## BendPak Technical Service Bulletin HD-973 Hydraulic Hose Extension

### BendPak TSB 141-072024

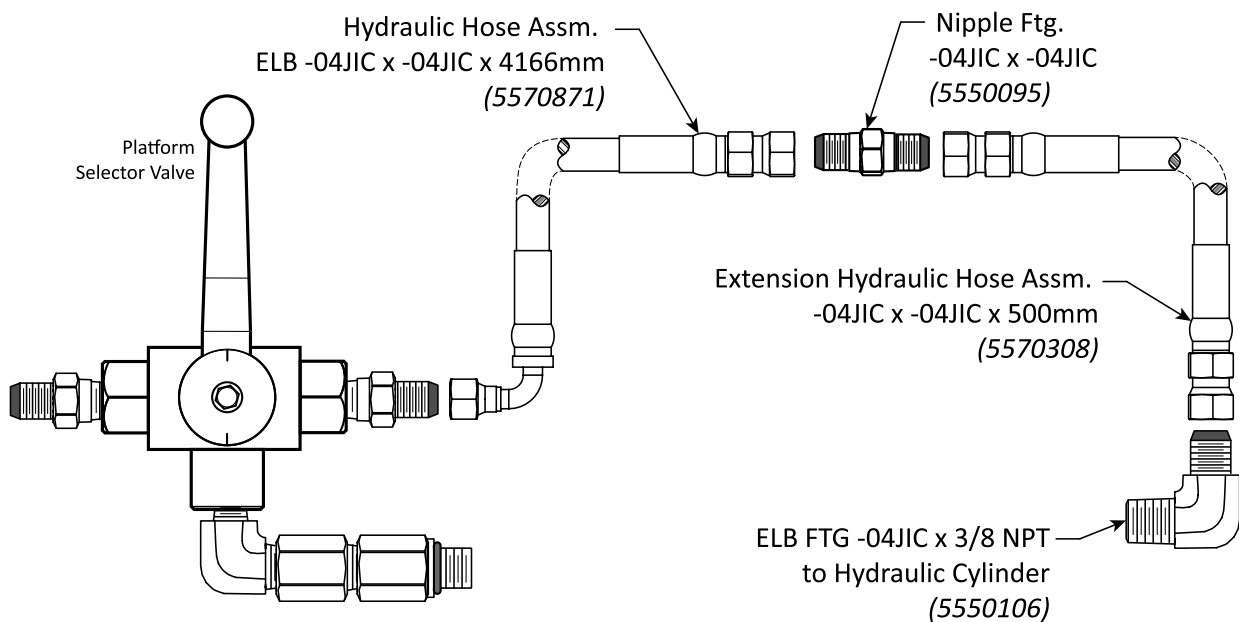
This TSB describes a change to the current HD-973P and HD-973PX Hydraulic Hose routing.

On all HD-973P and HD-973PX Four-Post Parking Lifts, an extension hose and nipple are added on the Hydraulic Hose routed to the Top Lift Platform. This extension will provide additional slack to allow a gentle hose bend radius extending the service life of the hydraulic hose.

The Extension Hose (5570308) will be attached to the existing Hydraulic Hose (5570871) through a JIC Nipple Fitting (5550095). Both Hydraulic Hoses will then be routed through the Flex Tube to the upper platform and then connected to the Hydraulic Cylinder as described in the Installation and Operation Manual (5900076). Refer to the figure below.
